APPEAL SUMMARY

Appeal ID: 15320	Project Address: 15000 N Lombard St
Hearing Date: 7/5/17	Appellant Name: John Carter
Case No.: B-016	Appellant Phone: 503-224-9560
Appeal Type: Building	Plans Examiner/Inspector: Jerry Englehardt
Project Type: commercial	Stories: 1 Occupancy: F-1, S-1, or B Construction Type: V-B
Building/Business Name:	Fire Sprinklers: Yes - West Wall
Appeal Involves: Erection of a new structure	LUR or Permit Application No.: 17-183588-CO
Plan Submitted Option: pdf [File 1]	Proposed use: Warehouse

RIVERGATE PHASE V 15000 N LOMBARD ST **PORTLAND, OR 97203**

CODE **ANALYSIS**

TRAVEL DISTANCE APPEAL

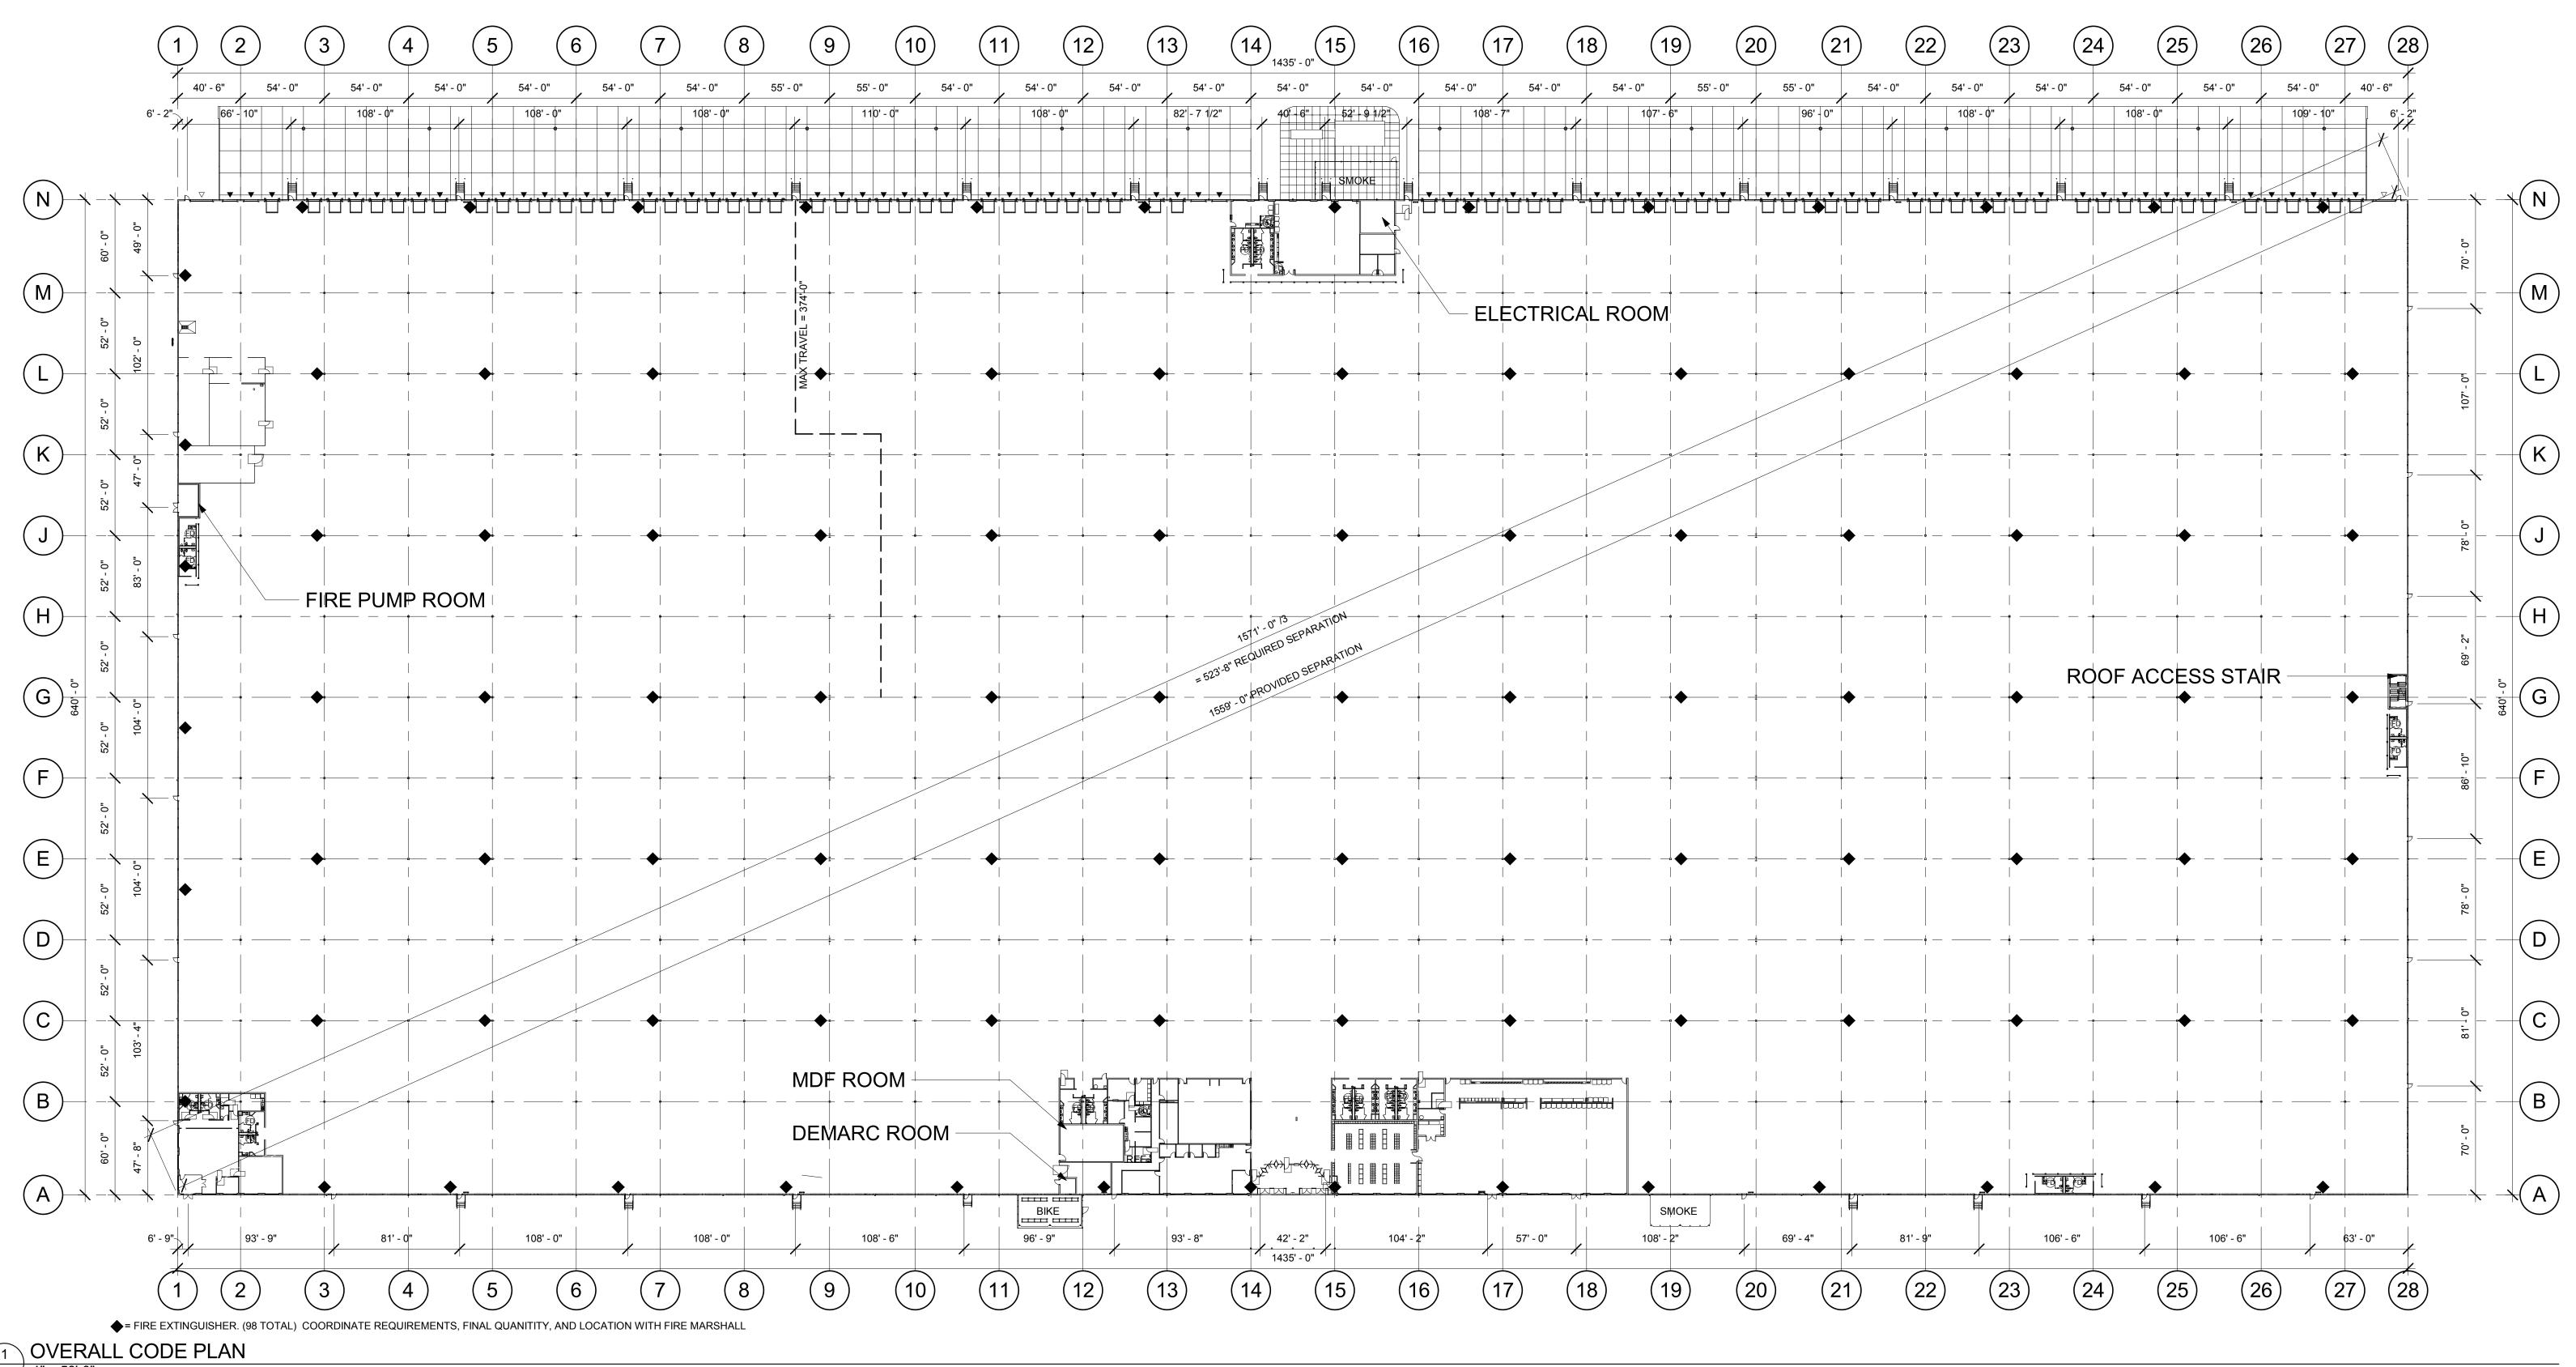
Requires	Per Table 1016.2, Occupancies F-1 and S-1 are limited to a maximum travel distance of 250 ft.
----------	---

The proposed design provides a maximum travel distance of 374 ft. However, 2015 IBC Section 1017.2.2 allows F-1 and S-1 occupancies to increase the maximum travel distance to 400 ft if the following conditions are met:

Limited to one story (Building is one story)

The finish floor to roof deck is a minimum of 24 ft (40-45 ft is provided)

The building is equipped throughout with an automatic sprinkler system in accordance with section

903.3.1.1 (An ESFR sprinkler system w/ fire pump is provided)

Reason for alternative We are requesting to be allowed to meet the 2015 IBC maximum travel distance requirement due to the size and desired function of the building. An ESFR sprinkler system is provided, and egress doors are provided approximately every 100 ft along the perimeter of the wall.

Increase in maximum travel distance to 400 feet per 2015 IBC: Granted as proposed for F1 / S1 occupancies.
